**STAFF RECOMMENDATION**

**CASE FILE NO.:** Z0391-19-D

**ADDRESS:** 11767 SE Highway 212  
Clackamas, OR

**PROPOSAL:** Design review of proposed 19,500 square foot industrial building expansion and including new loading docks and other site improvements.

## Building Elevations

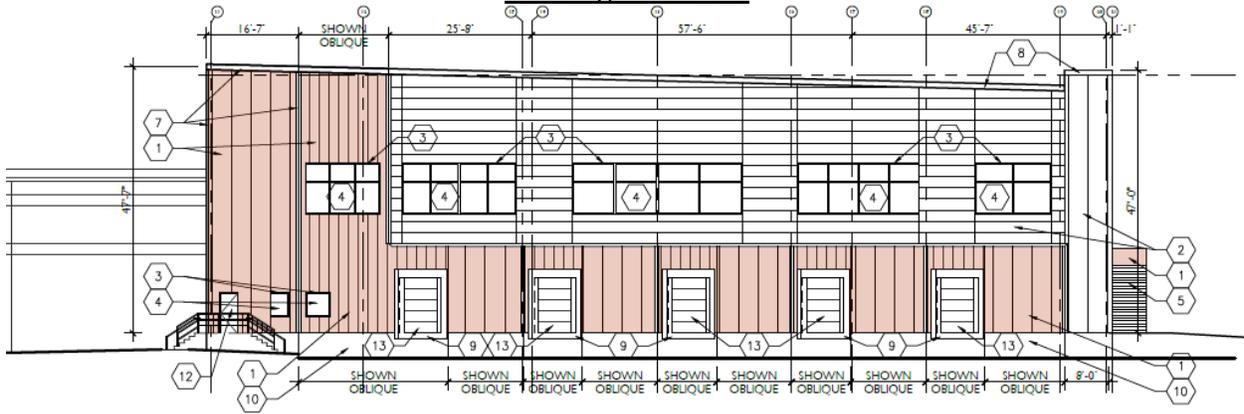
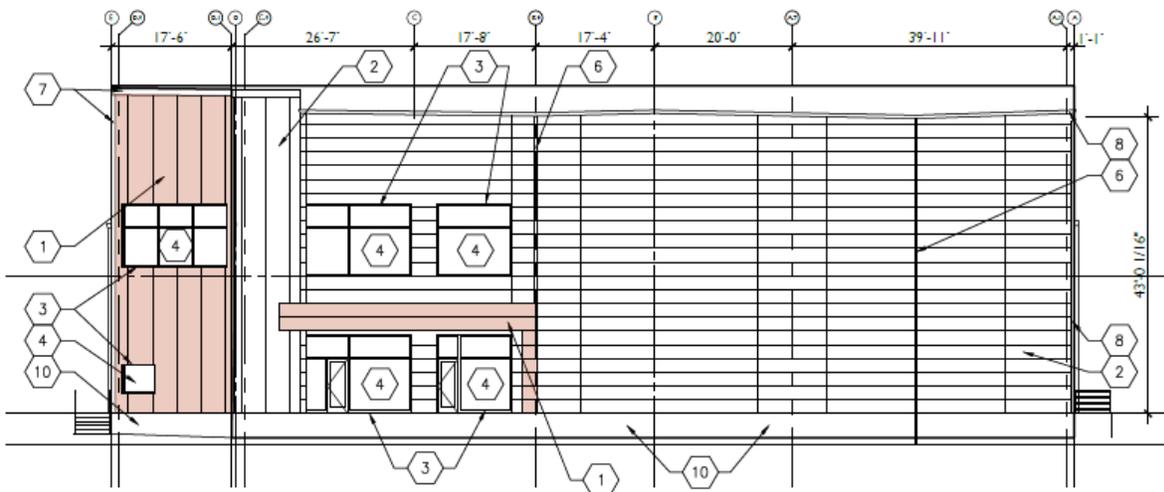
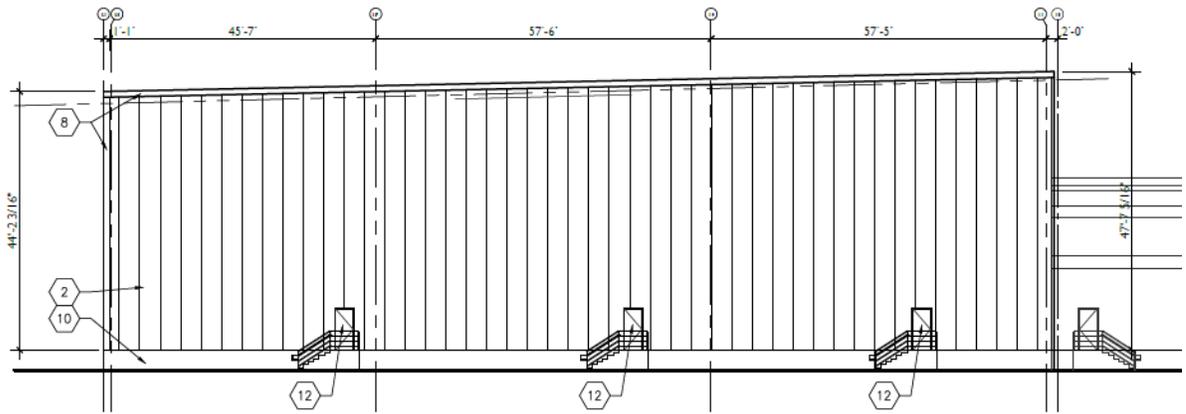
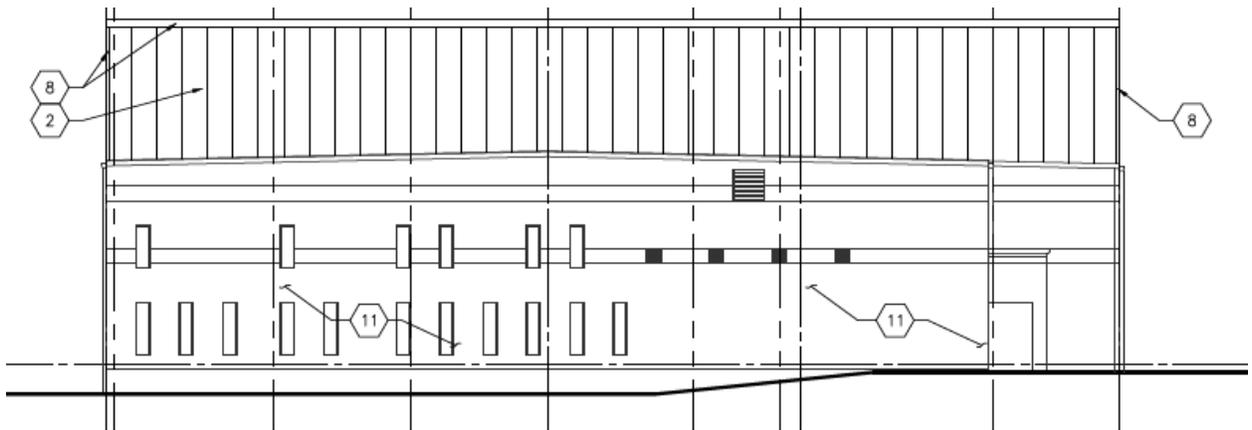
**Finding:** The proposed building addition has architectural relief and visual interest along its visible facades through the saw tooth design of the loading dock, contrasting building colors, and building materials that create variety and depth along the façade. No changes are proposed to the previously approved public entrance or along walkways. The design of the building is consistent with its proposed use and level of public exposure. The different uses between the ground floors (refrigerated storage) and upper level (office) is expressed through changes in fenestration and façade material. The roof, which is moderately sloped for drainage is screened with a projecting parapet line which contrasts and provides visual interest at the top of the building. The façade materials are consistent with the neighborhoods visual identity, durable, and consistent with the proposed use of the building. The applicant has expressed that owing to their striated nature and lack of visible mounting hardware, the proposed materials are consistent with the example list of materials in ZDO1005.04(E)(3). Per the above findings and the applicant’s submitted drawings, the proposed building complies with the relevant standards of section 1005.04. These standards are met.
